MANDATORY SERVICE BULLETIN**NUMBER:** SB11-16**REVISION:** 00**DATE:** 10/07/2011**SUBJECT:** CREW SEAT STOP BRACKET ADDITION**EFFECTIVITY:**

KODIAK 100 Series Aircraft Serial Numbers: 100-0001 through 100-0055

Crew Seat Stop Bracket Addition

FSI-024

Figure 1-1: Component Removal

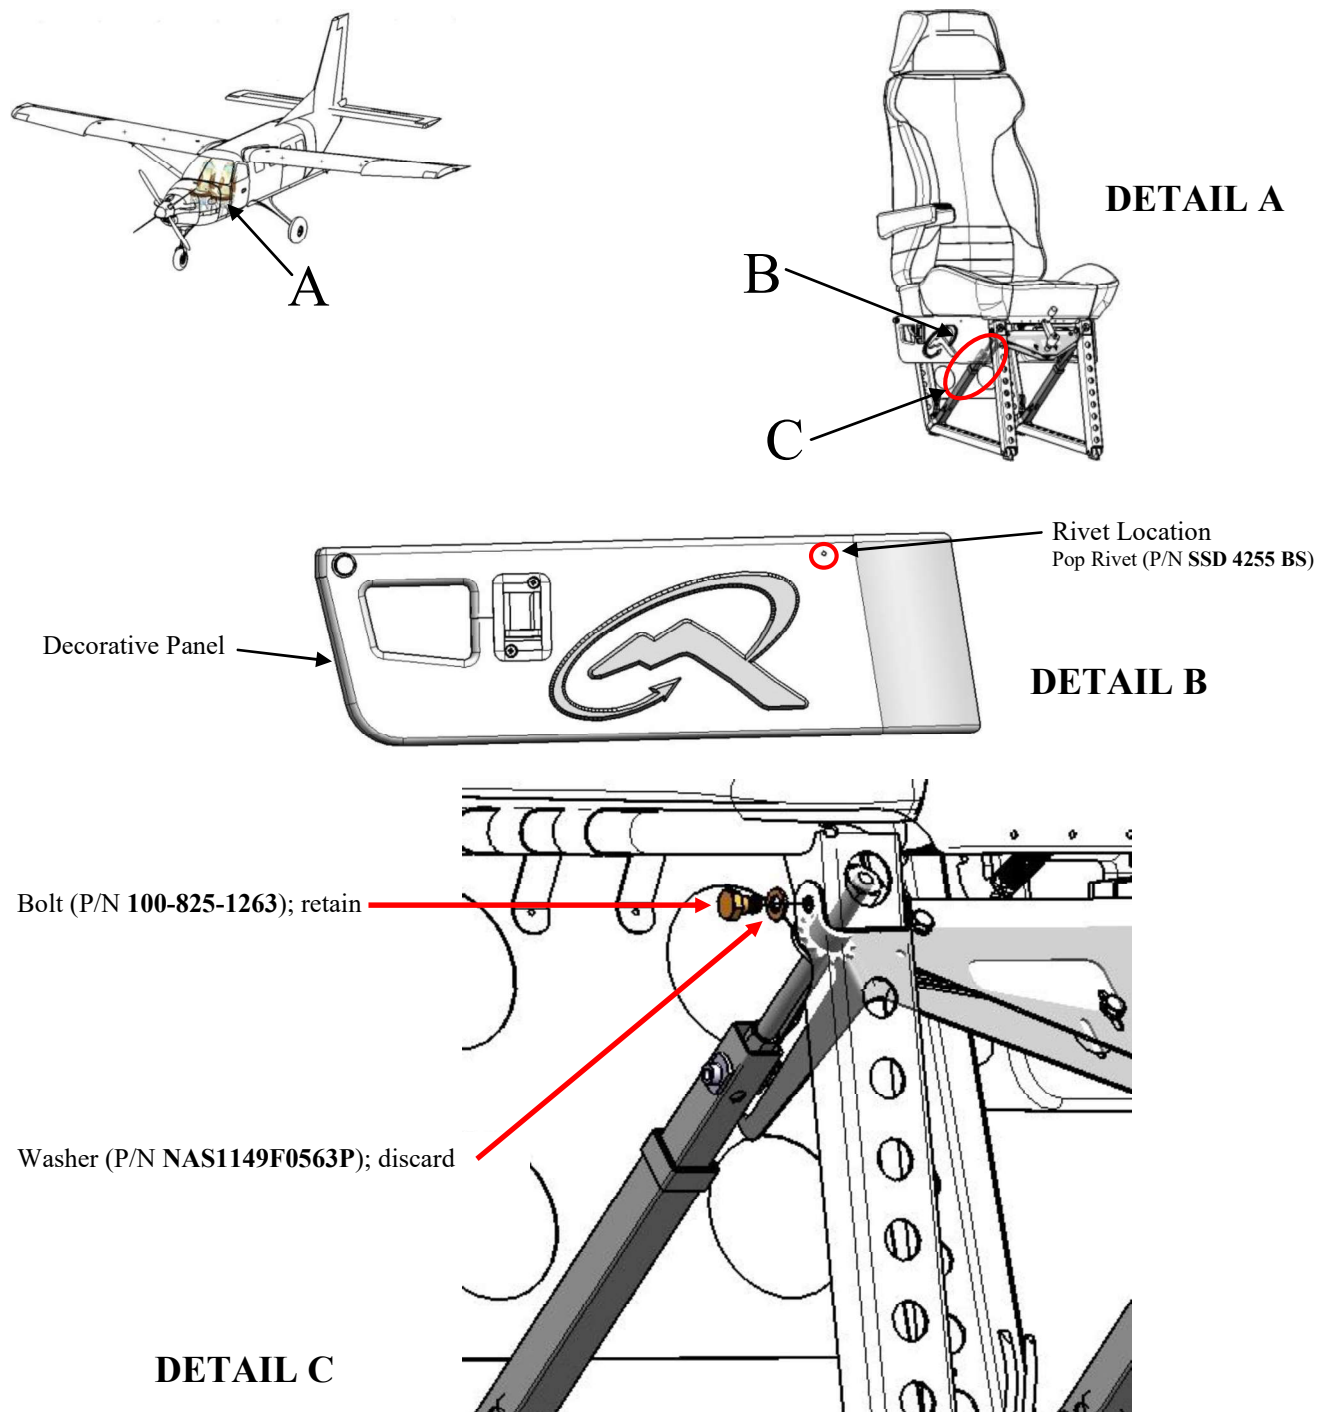
During the component removal and stop bracket installation, it is possible to pull the crew seat decorative panel aside enough to provide a sufficient working area. It is acceptable to remove the pop rivet indicated in **Figure 1-1, Detail B** to provide a larger working area. A new pop rivet (P/N SSD 4255 BS) will need to be installed after the installation of the stop brackets in **Section 6**. Follow all the manufacturer's installation and safety instructions.

Remove the bolt (P/N 100-825-1263) and washer (P/N NAS1149F0563P) on both outboard sides of the crew seat as shown in **Figure 1-1, Detail C**. Discard the washer (P/N NAS1149F0563P), but retain the bolt (P/N 100-825-1263) for use in **Section 6**.

Figure 1-2: Stop Bracket Installation

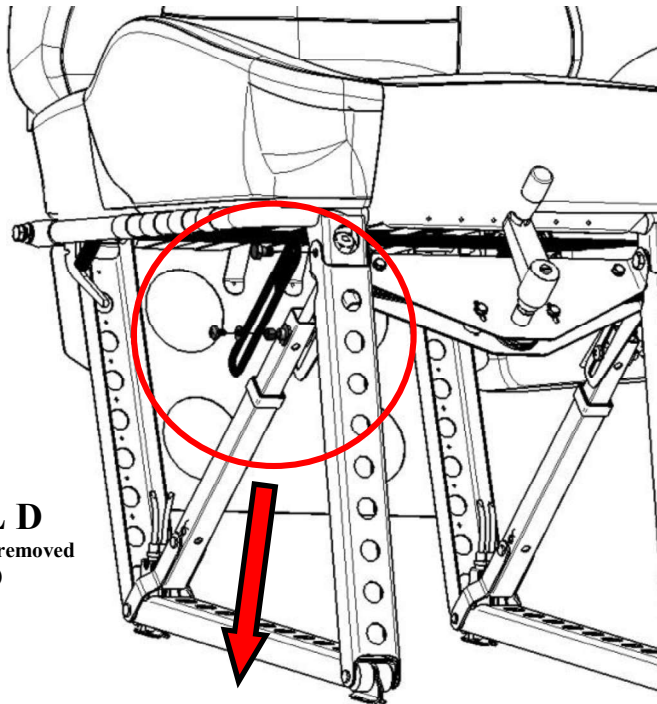
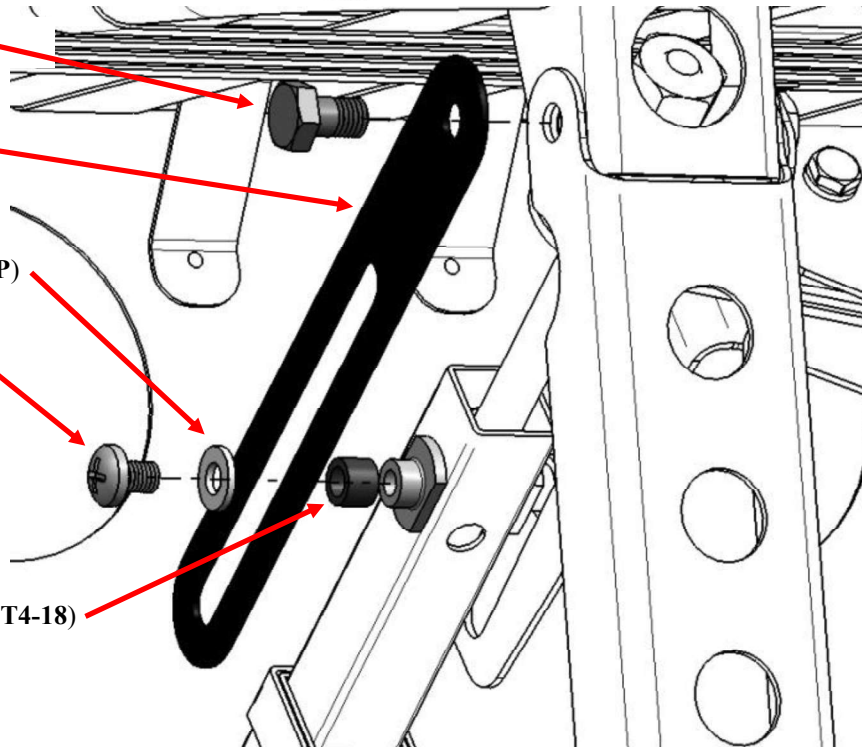
Position the stop bracket (P/N 100-825-1246), spacer sleeve (P/N NAS43HT4-18), and washer (P/N NAS1149F0463P) securing them into position with the pan head screw (P/N MS27039-4-10) as shown in **Figure 1-2, View E**. Torque the pan head screw to 50-70 in-lb.

Position the stop bracket (P/N 100-825-1246), apply Loctite® 222MS® to the bolt (P/N 100-825-1263) threads, and secure as shown in **Figure 1-2, View E**. Torque the bolt to 65-75 in-lb.
